# Supplement to Final Environmental Impact Statement for Proposed Issuance of a New Source National Pollutant Discharge Elimination System Permit to Estech, Inc.'s Duette Mine Manatee County, Florida

EPA 904/9-82-104
December, 1982

# Environmental Impact Statement Supplement

# Estech, Inc.
# Duette Mine
# Manatee County, Florida

FIGURE 2-2

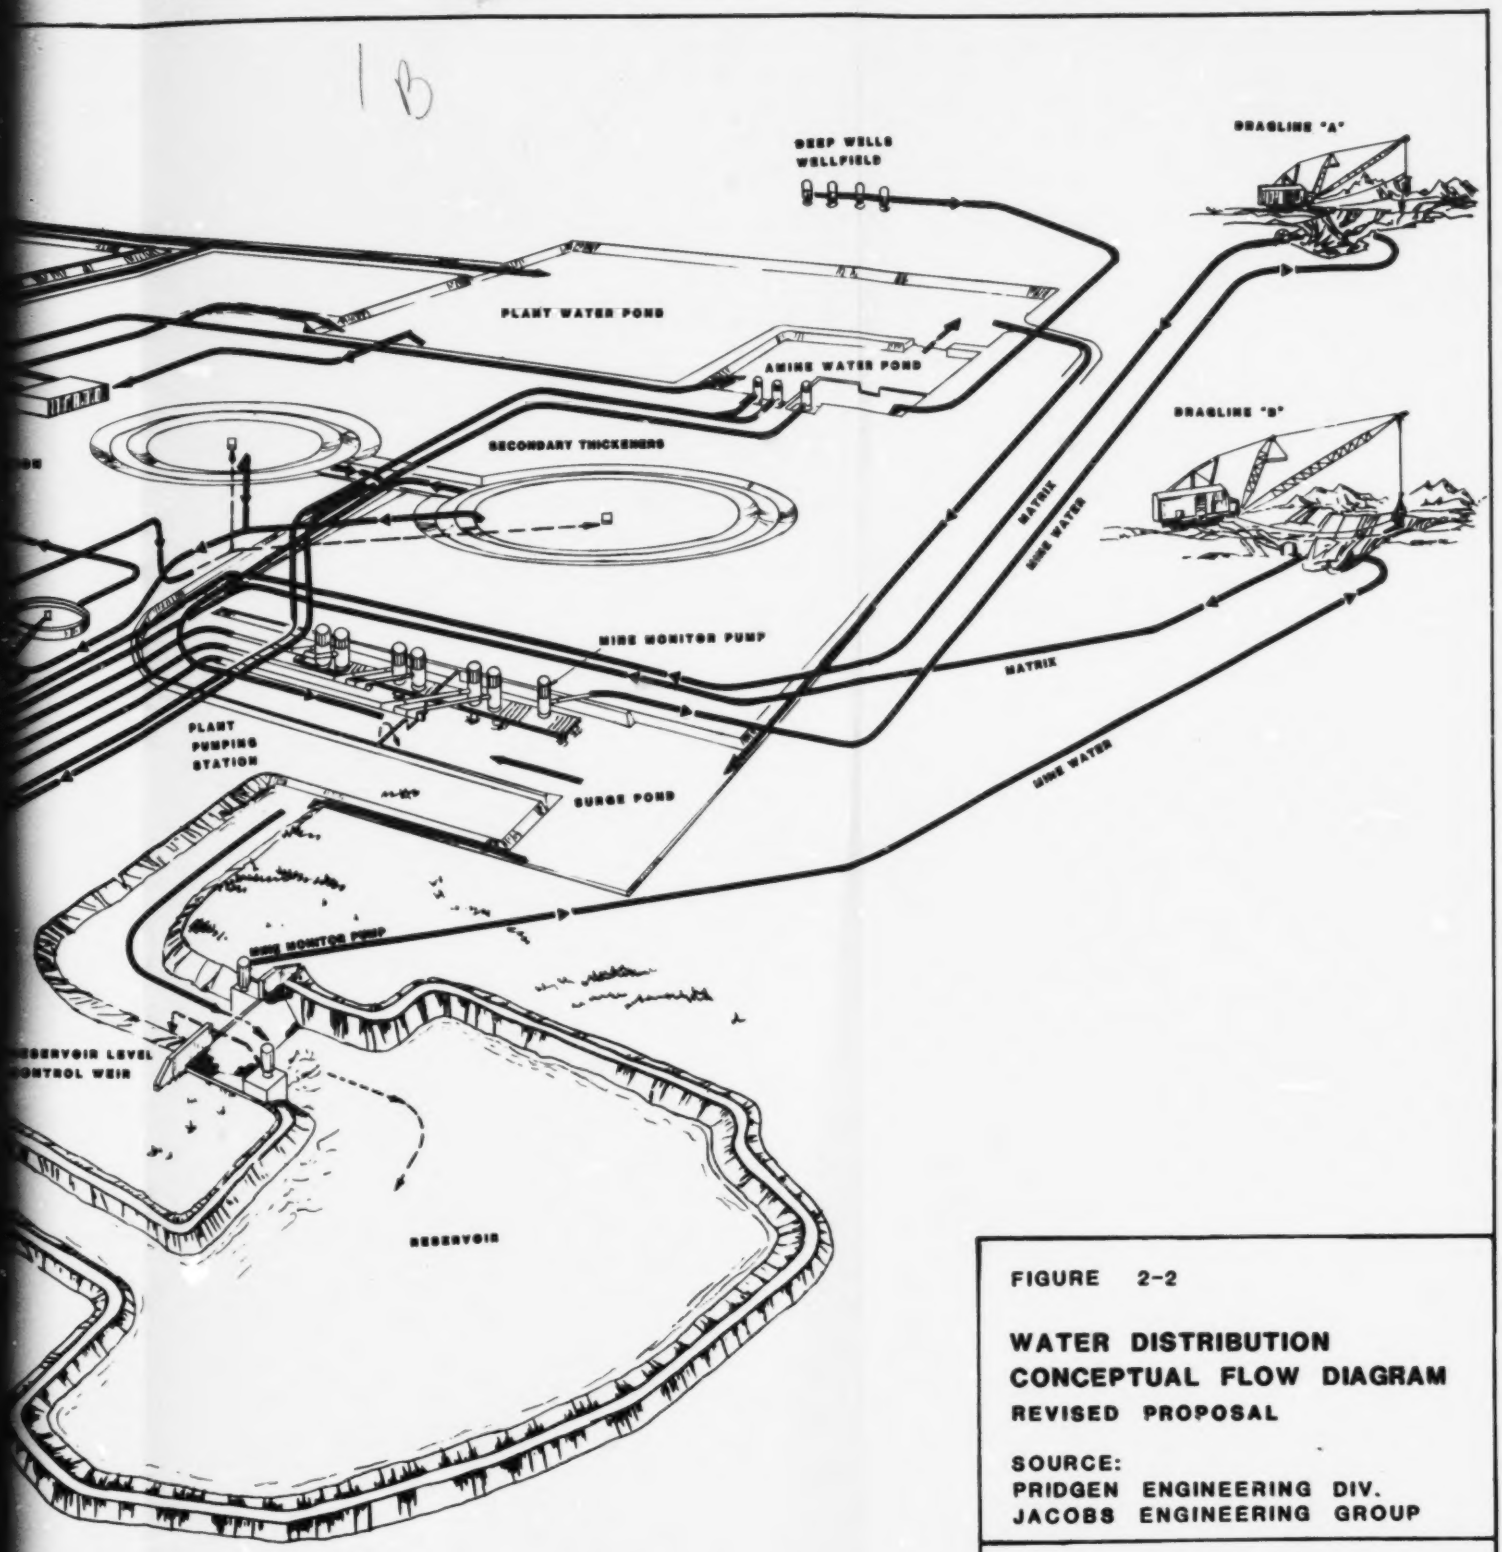
Elimination of Surface Water Intake - As originally proposed, Estech would have constructed a stationary weir designed to direct excess flow from the East Fork of the Manatee River under high flow conditions into an on-site reservoir (Figure 2-1). Under the current plan, there would be no diversion and impoundment of waters of the United States (Figure 2-2).

around the reservoir for additional water storage capacity. These changes eliminate the capability to divert water from the East Fork Manatee River and result in two discharge points (001 and 002) being in direct flow alignment with each other. Discharge point 001, being upstream of 002, becomes redundant and is therefore proposed to be eliminated. Discharge point 002 would be positioned to control discharges (if any) at the downstream end of the reservoir. No change in discharge point 003 is proposed.

FIGURE 2-9

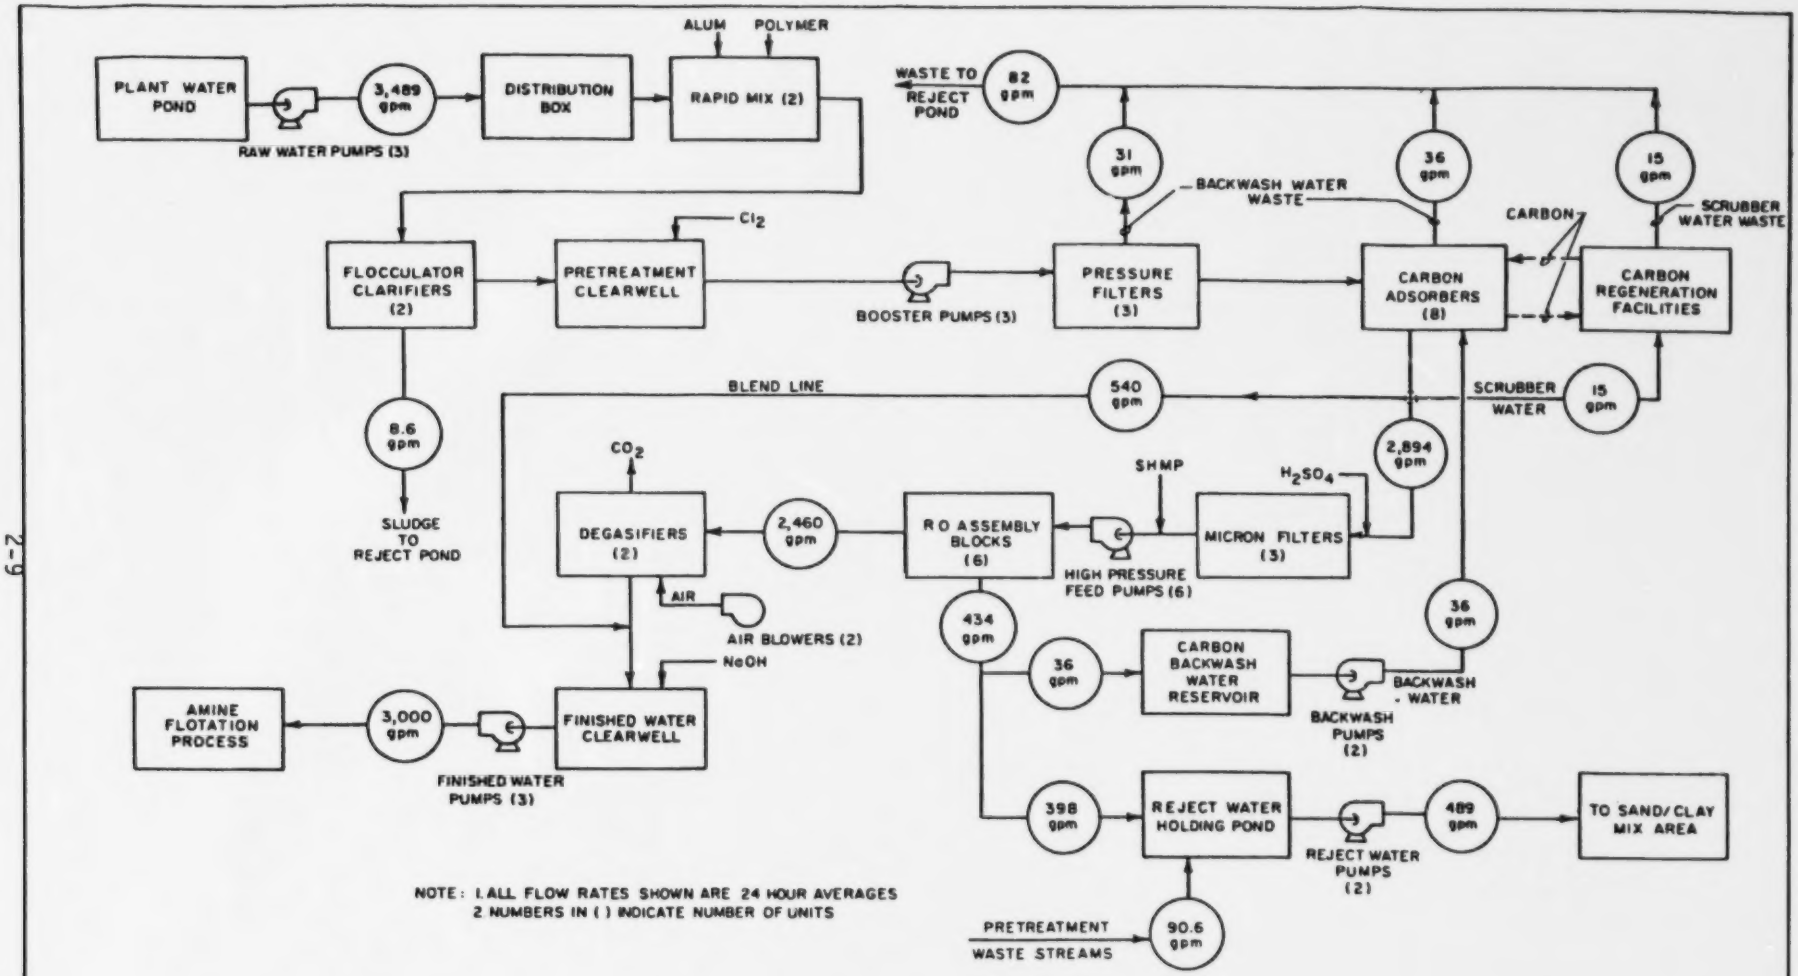
Installation of Recycle Water Preparation Facility - As a means of reducing pumpage of ground water, Estech proposes to use recycled process water in the flotation circuit. Periodically during the mine life, it may be necessary to treat the recycle water to provide the high quality water needed for the flotation process. Although several water treatment methods are possible, a reverse osmosis facility is currently being considered.

Recycled water requires several pre-treatment operations upstream of the R/O assembly blocks to prevent membrane fouling. A conceptual flow schematic of Estech's proposed R/O facility design is provided in Figure 2-3. The sequence of operations for the R/O facility is:
